**Title: BRIEFING ON STATUS OF DOE'S HIGH-LEVEL
WASTE PROGRAM - PUBLIC MEETING**

Date: Monday, October 31, 1994

4 BRIEFING ON STATUS OF DOE'S
5 HIGH-LEVEL WASTE PROGRAM

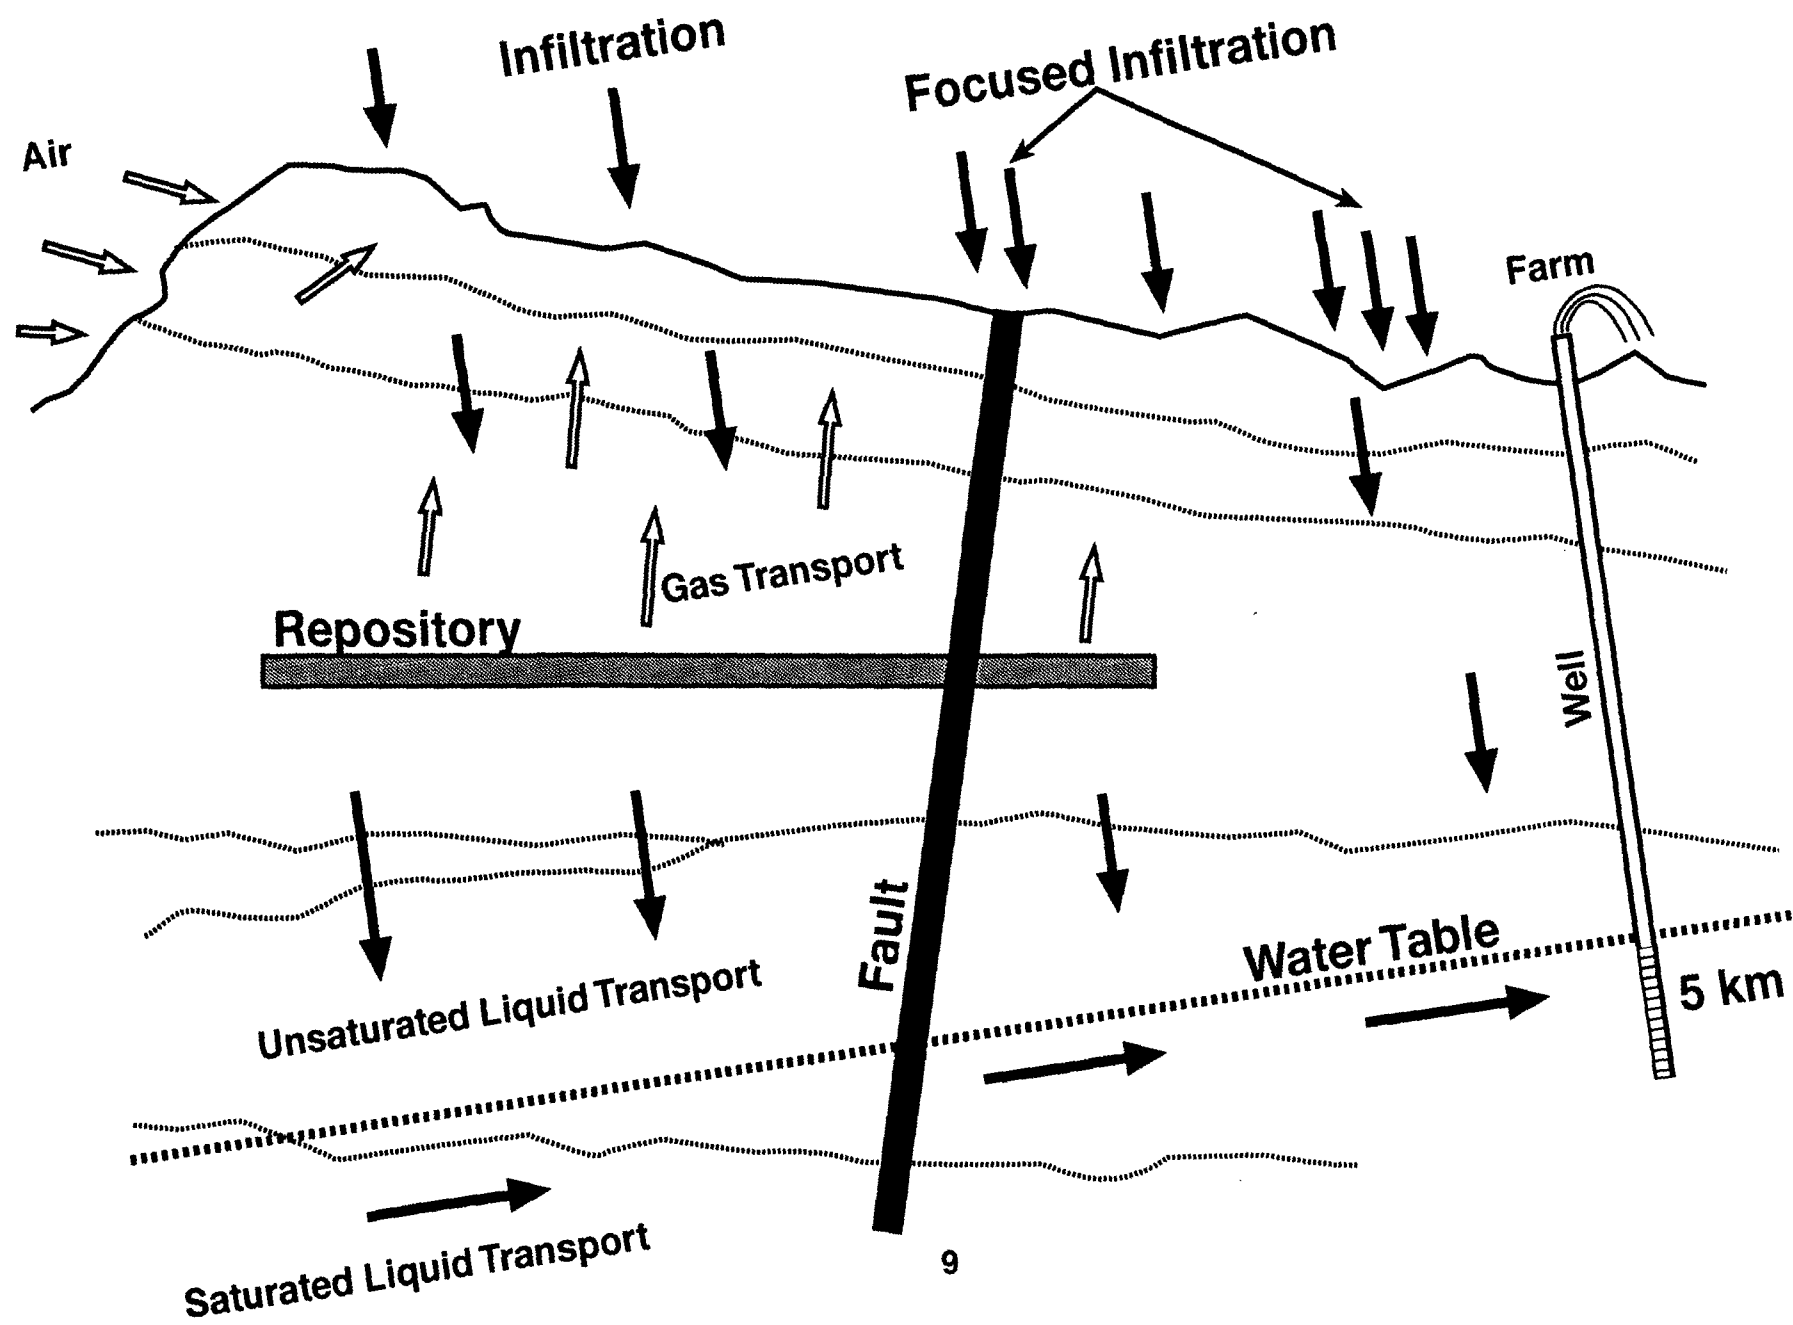
9 DR. KNAPP: Moving on to slide 6, which is a
10 difficult slide to see on the camera, television, but
11 hopefully your package will make it easier to see, this is
12 from the five year plan and it shows some of the products
13 they will develop for site suitability and for licensing.
14 There are a number of things we can draw from this figure.
15 We can see a certain parallelism that DOE is looking at
16 licensing at the same time they're developing site
17 suitability. One of the suggestions that I get from this is
18 that there are too many products here. I would like to see
19 if we can work with DOE and reduce the number of products.
20 I'm concerned that there may be redundancies between what
21 they produce for site suitability and what they produce for
22 licensing development. Hopefully we can find that some of
23 these products would serve a dual purpose.

24 Just noting a couple features of the future, the
25 stars on the top row, one and two, are the site suitability

1 decision and the recommendation to the President on using
2 the site, which they make in the year 2000. In the next
3 row, the diamonds are the higher-level findings I spoke to a
4 moment ago which will be used to support the site
5 suitability decision and the recommendation. This would
6 lead to our interest in these findings because if the
7 findings are folded almost directly into the recommendation,
8 upon which we will comment by law, then we have a keen
9 interest in exactly what is said in those findings.

10 Again, this leads to questions such as why are the
11 higher-level findings being made in this order at this time?
12 We need to understand better their rationale. Is it because
13 there is a performance assessment or performance allocation
14 that leads to these or is it simply that the data happens to
15 be there and they're doing them in this order? We need to
16 know that.

9 DR. KNAPP: One other item. If you were to look
10 at the legend on slide 7, you do find in the lower left-
11 hand corner some design products which they will be bringing
12 forward, including an advanced conceptual design I think in
13 March of 1997. The question in my mind -- and Mr. Bernero
14 has described what in fact will be in that design. Even if
15 it's all in the design, it raises the question March of 1997
16 is nearly two and a half years ago. Isn't that long if
17 they're going to be bringing in higher-level findings
18 earlier than that?

16 DR. KNAPP: There are certain errata in both the
17 figure and the legend. We took those directly from the DOE.

SITE SUITABILITY EVALUATION PROCESS

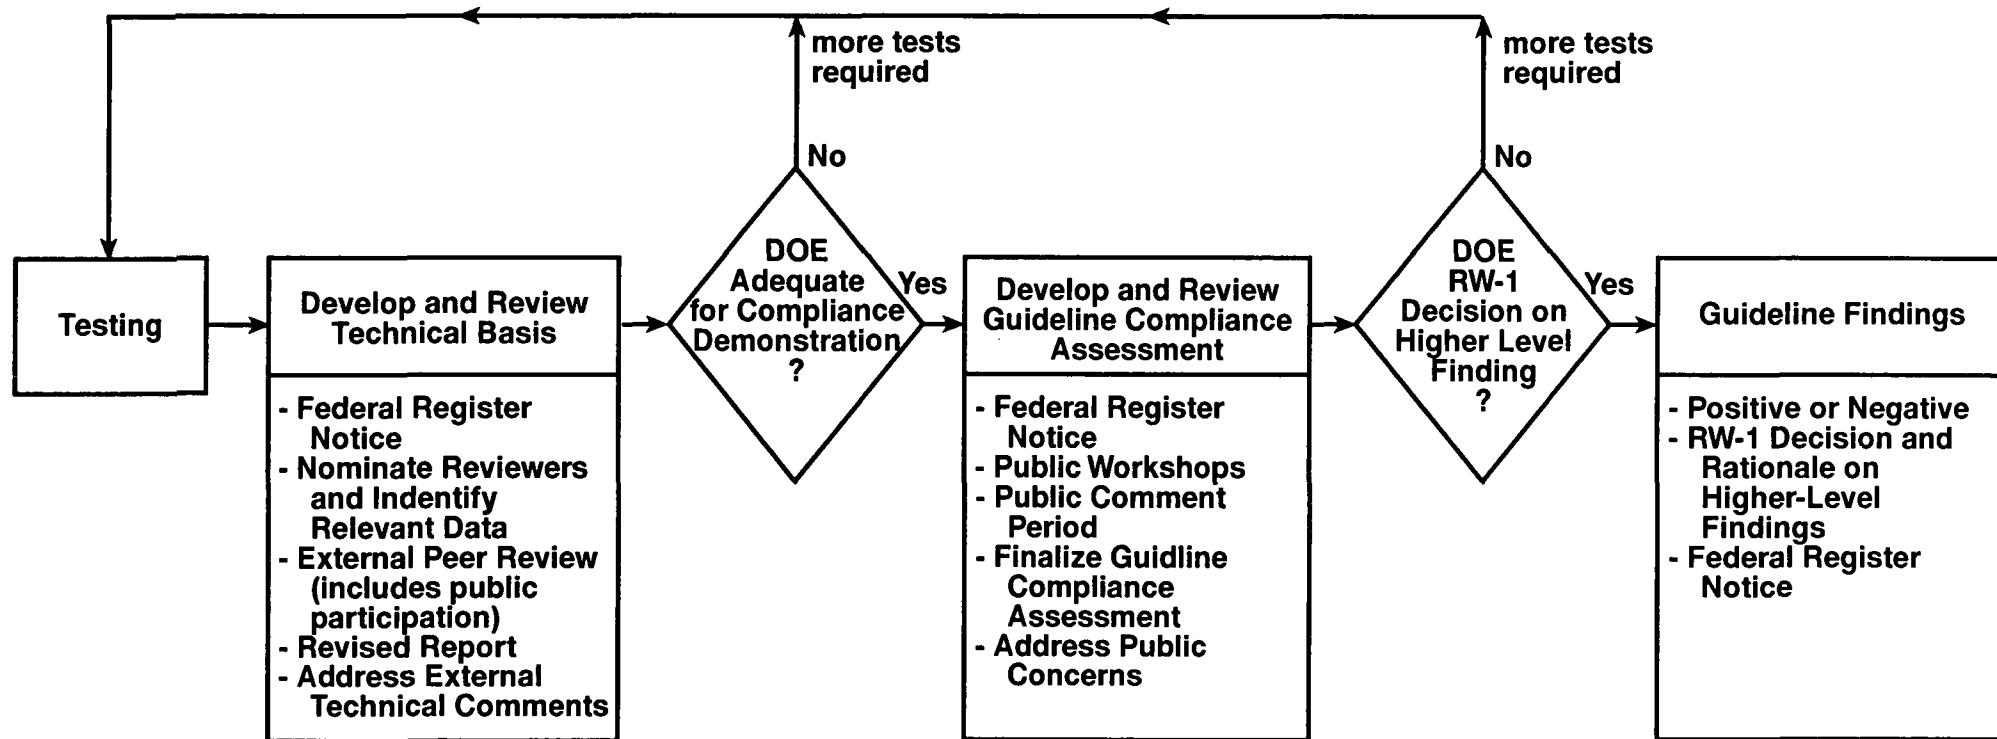
4 After they initially create a report which is the
5 basis of the finding, they will then, in this box here,
6 which I appreciate the screen does not permit you to see
7 outside of looking at your own handouts, they will submit
8 this for external peer review. This peer review will be
9 conducted according to their current plans by the National
10 Academy of Science, and there is provision included for
11 public participation. Here's an example of DOE's being
12 responsive over the last few months. Originally this was to
13 have been public observation. The people of the State of
14 Nevada wanted public participation and DOE has changed their
15 philosophy to accommodate this.

16 Following the peer review, DOE will make a
17 decision as to whether they, in fact, think that the higher-
18 level finding has been appropriate and, if not, they will go
19 back and do additional work. If they have, then they will
20 submit this for a second public comment period in which the
21 public may say, "We do or do not believe the conclusions
22 you've reached based on the peer review makes sense."

23 It's my expectation that the NRC staff would
24 comment here during the first public comment period. We
25 would look at how DOE has responded to our comments and in

1 the second comment period we would say whether or not we
2 felt their response had been appropriate. This would be
3 involvement as a federal agency commenting as opposed to
4 their submitting it directly to us. This would go out to
5 the public, we would comment as an agency, as part of that
6 public, but DOE is certainly receptive to our comments.
